CITY OF WASHINGTON, ILLINOIS

Public Safety Committee Agenda Communication

Agenda Item: Oak Creek Subdivision Street Connection Consideration

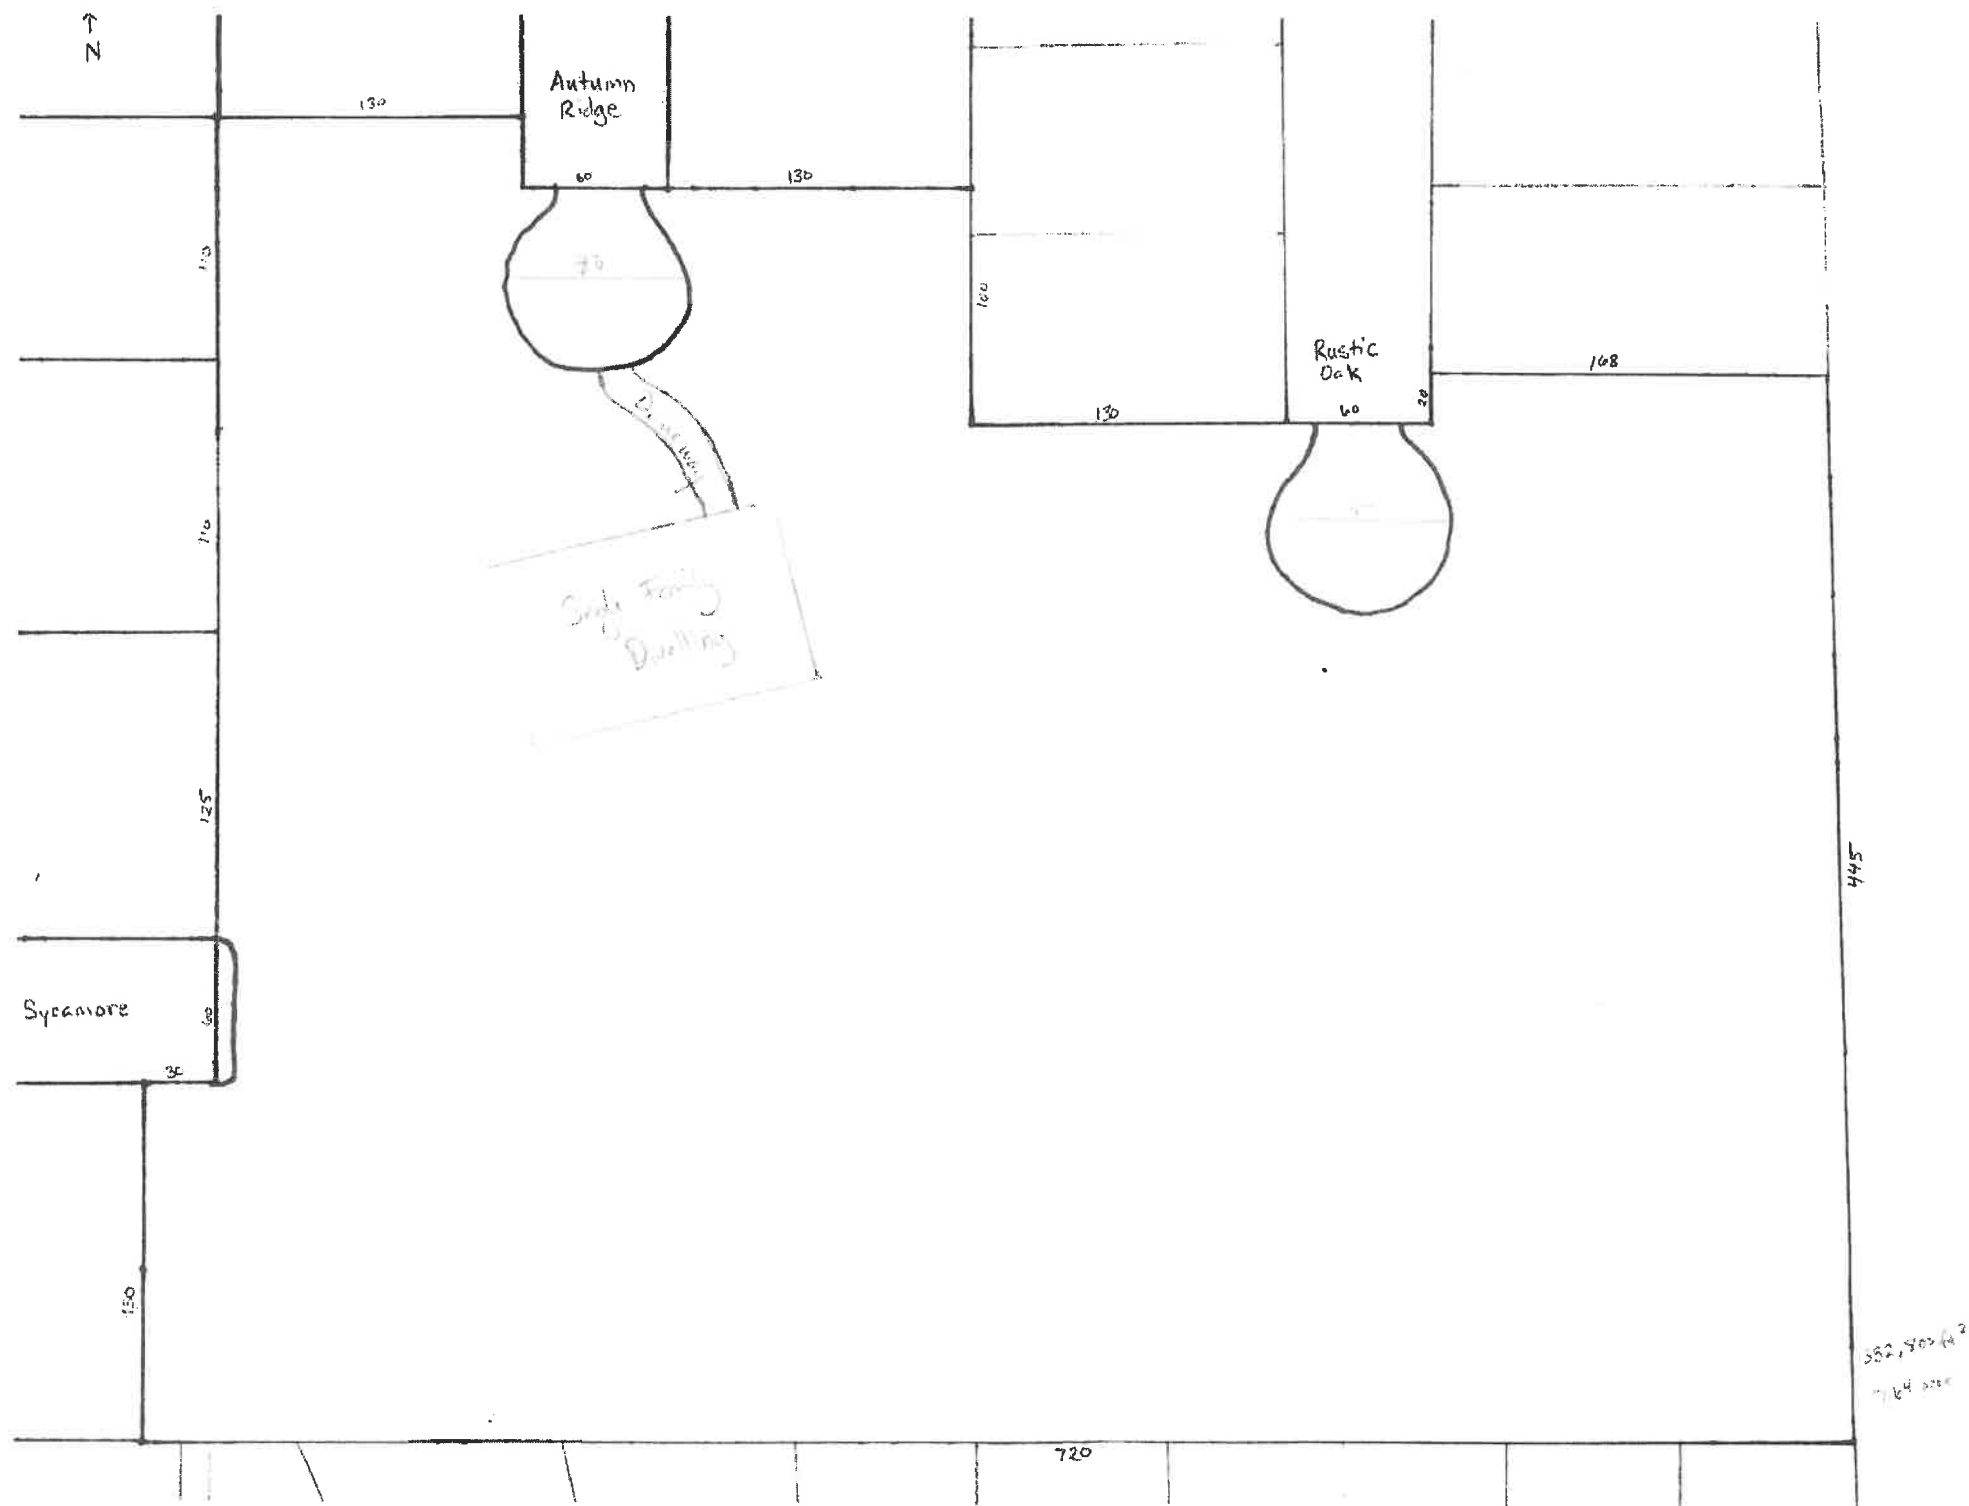
The property is currently owned by Villa 5, LLC, which was the developer for Section 7. A prospective buyer recently asked staff about the possibility of constructing a sole single-family house on the lot. While this is a permitted use, staff raised some concern about the planned connectivity of Autumn Ridge and/or Rustic Oak with Sycamore. Both Autumn Ridge and Rustic Oak are intended to connect with Sycamore upon the construction of future Oak Creek phases. Neither of these roads currently have properly designed cul-de-sacs. Rustic Oak in particular is about 1,070' in length, which exceeds the maximum allowable subdivision code regulation of 600'.

Staff has informed the prospective buyer that, at a minimum, proper cul-de-sacs would need to be constructed on Autumn Ridge and Rustic Oak to allow for public safety and public works vehicles to safely maneuver. There is less concern about constructing a cul-de-sac on Sycamore, as both of the homes on the east side of the intersection of Oak Ridge and Sycamore allow for additional means of access, though a cul-de-sac may also be warranted there. However, consideration should also be given to extending Autumn Ridge and/or Rustic Oak to provide a connection with Sycamore.

1. Connect Autumn Ridge with Sycamore and construct a cul-de-sac at the end of Rustic Oak;
2. Construct a U-shaped connection between Autumn Ridge and Rustic Oak; and
3. Construct cul-de-sacs at both Autumn Ridge and Rustic Oak.

The PWC discussed this at its meeting on September 7. It was open to allowing cul-de-sacs that are constructed to City specifications be the allowable option, though connecting Autumn Ridge with Sycamore was not ruled out either. The direction was to have further discussion with the Public Safety Committee following the submittal of a site plan by the prospective buyer showing the preferred placement of a house. From a staff public works and public safety perspective, thought could also be given to having a hybrid of the U-shaped connection between Autumn Ridge and Rustic Oak but to have two 90-degree turns connecting those two streets.

Action Requested: Staff requests direction on what the City would require for the extension of any of these three streets in Oak Creek. Attached is a draft site plan submitted by the prospective buyer showing the preferred placement of a house should there be the ability to locate this with cul-de-sacs constructed at Autumn Ridge and Rustic Oak.
